**MONTGOMERY COUNTY HISTORIC PRESERVATION COMMISSION**  
**STAFF REPORT**

<b>Address:</b>	106 Tulip Avenue, Takoma Park	<b>Meeting Date:</b>	5/22/2024
<b>Resource:</b>	Outstanding Resource <b>Takoma Park Historic District</b>	<b>Report Date:</b>	5/15/2024
<b>Applicant:</b>	Louise Klee (Jennifer Goon, Agent)	<b>Public Notice:</b>	5/8/2024
<b>Review:</b>	HAWP	<b>Tax Credit:</b>	yes
<b>Permit Number:</b>	1068716	<b>Staff:</b>	Dan Bruechert
<b>Proposal:</b>	Door Replacement

The applicant proposes to remove and replace a set of doors.

LINE	MARK UNIT	PRODUCT LINE	ITEM	NET PRICE	QTY	EXTENDED NET PRICE
6	French Door- Standard Size	Elevate	Elevate Assembly RO 92 5/16" X 80" Entered as Size by Units	14,856.91	1	14,856.91

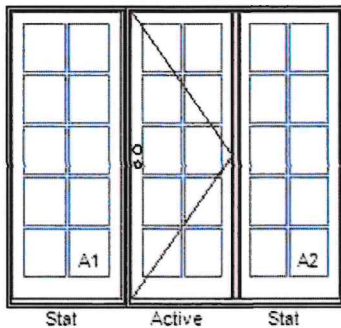
The new doors will fully fill the existing opening and Staff finds the multi-light configuration will not detract from the vernacular house style. However, Staff does not find the exterior of the proposed material to be appropriate. Fiberglass exteriors tend to appear too shiny when first installed, then dull over time, and are not an effective substitute material for a wood door. Staff does not recommend the HPC approve the proposed Marvin Elevate door. However, because this is not a historic opening, Staff

finds that either a wood or aluminum-clad wood door would be acceptable. The HPC has found that aluminum-clad wood windows and doors provide a finish and profiles that are close enough to painted wood to be an acceptable substitute in additions, new construction, and for ‘Non-Contributing’ resources. Staff finds an aluminum-clad door would be appropriate in this instance and would recommend the HPC approve either a wood or aluminum-clad wood door. The Marvin Signature Ultimate series (aluminum-clad wood doors and windows) would be acceptable.

While the subject property is categorized as an ‘Outstanding’ resource where a wood door would be typically required, Staff finds that is an instance where a substitute material would be acceptable. First, the subject property is designated as ‘Outstanding’ for its association with B.F. Gilbert and not for its architectural merit. Second, the opening is not historic, as we have documentation that shows the HPC approved the opening in 1995. Third, this is on the rear of the house and due to its placement far away from the road, is not at all visible from the public right-of-way.

Staff recommends the HPC approve this HAWP with the condition that the approved door is either wood or aluminum clad. Final approval authority can be delegated to Staff to verify this condition has been satisfied.

1. The replacement doors must be wood or aluminum-clad wood. Final approval authority to verify this condition has been satisfied is delegated to Staff; under the Criteria for Issuance in Chapter 24A-8(b)(1), (2), and (d), having found that the proposal, as modified by the condition, is consistent with the *Takoma Park Historic District Guidelines* and the purposes of Chapter 24A;

D-1 (Rear)  
on deck

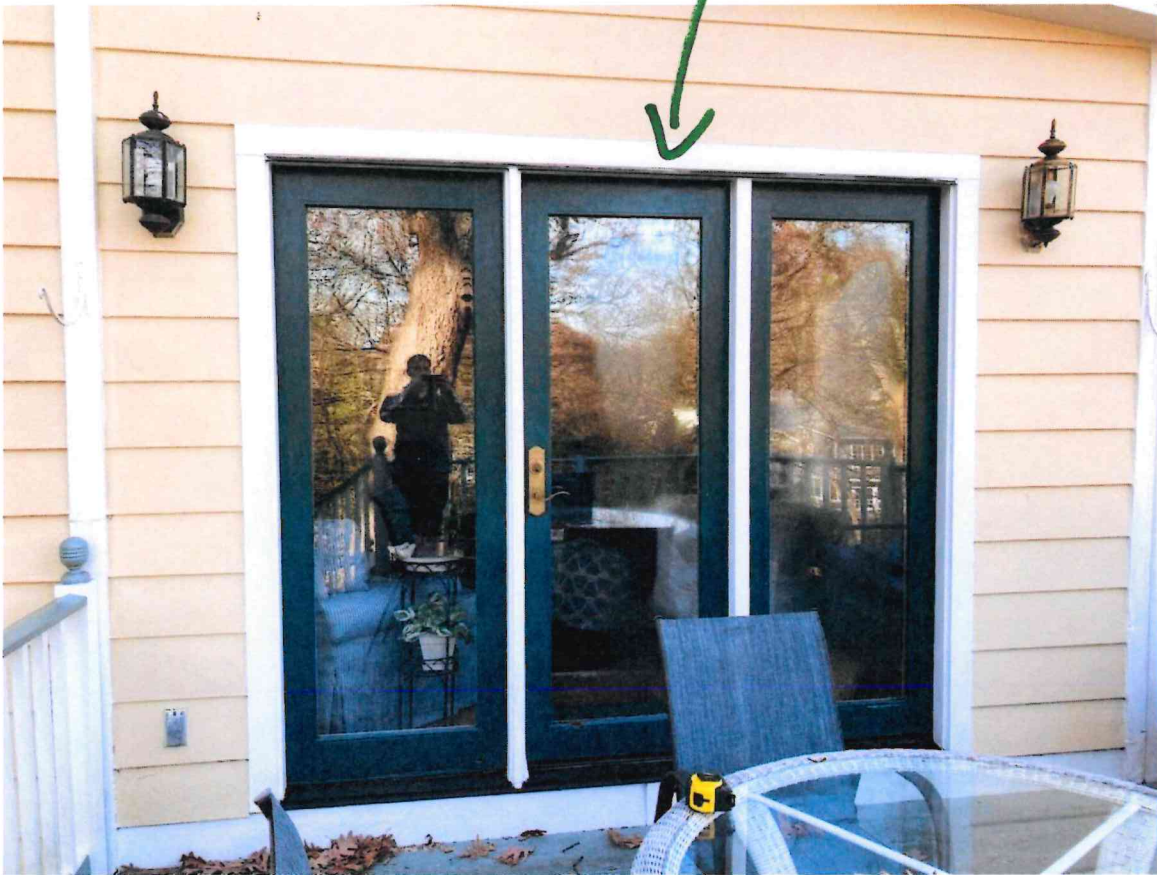
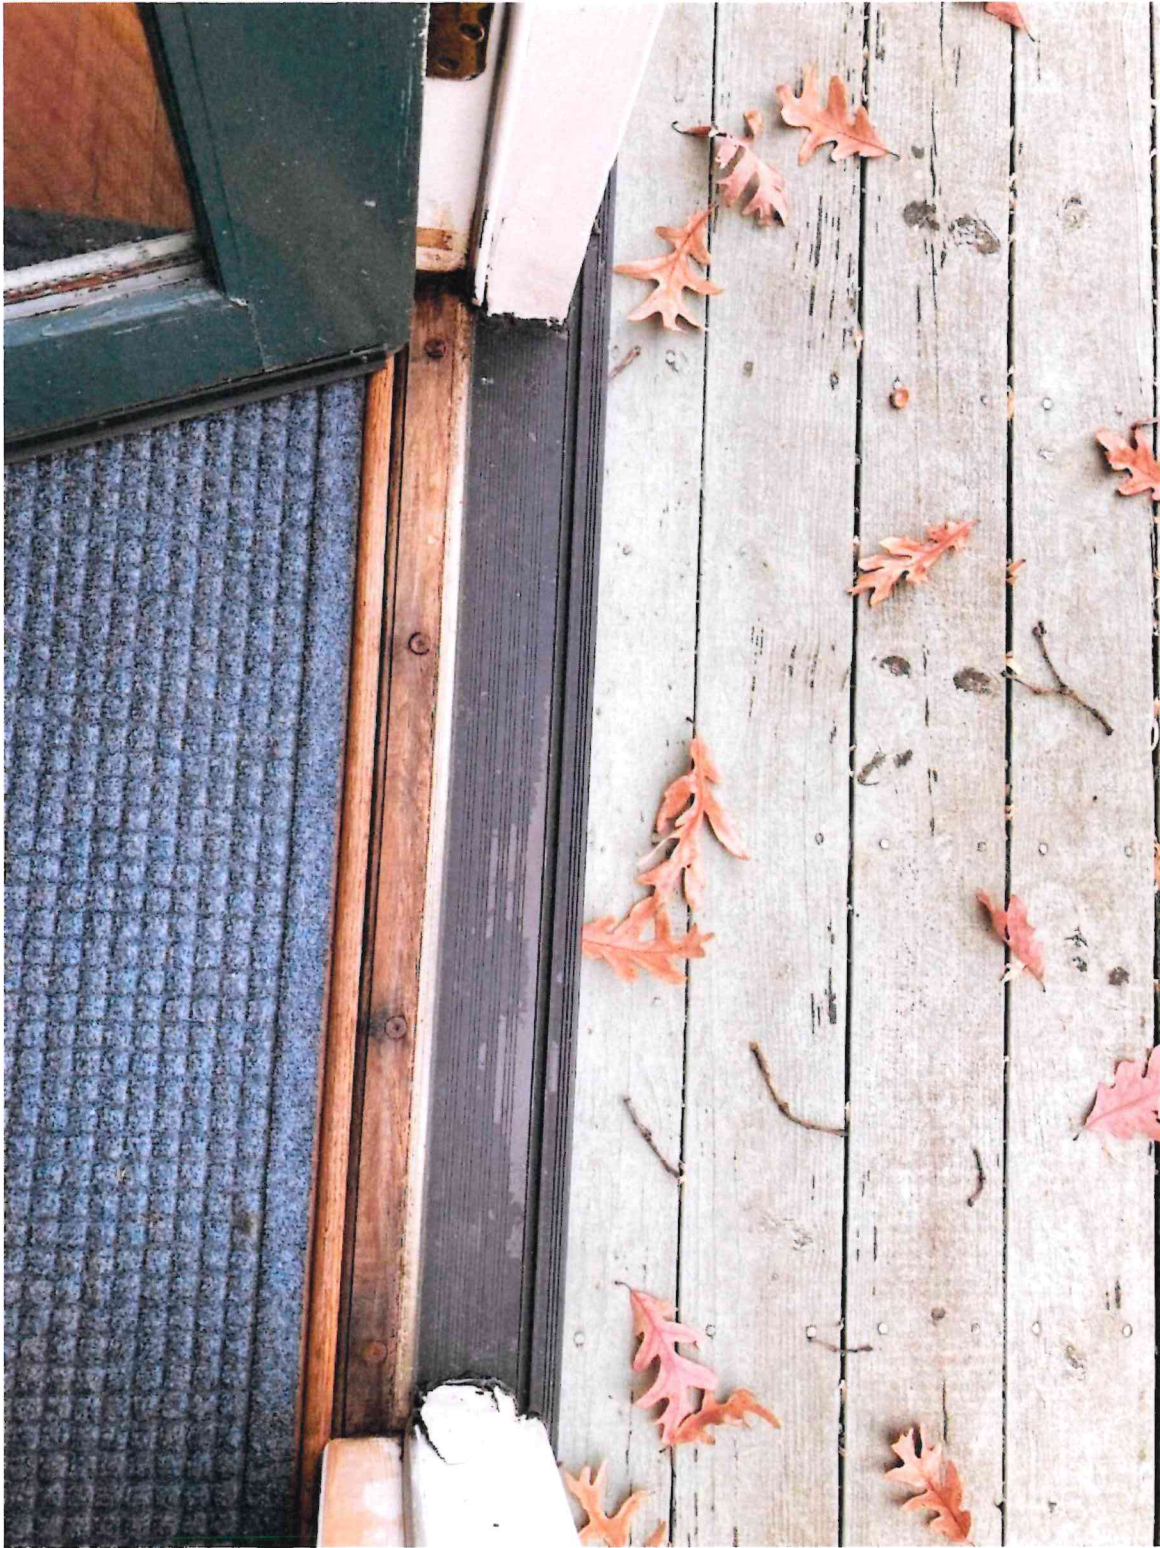
Staff finds the existing doors are failing and showing signs of rot and cannot be repaired. Removal and replacement is the appropriate course of action and Staff recommends the HPC approve the door removal under 24A-8(b)(2) and Standard 2.
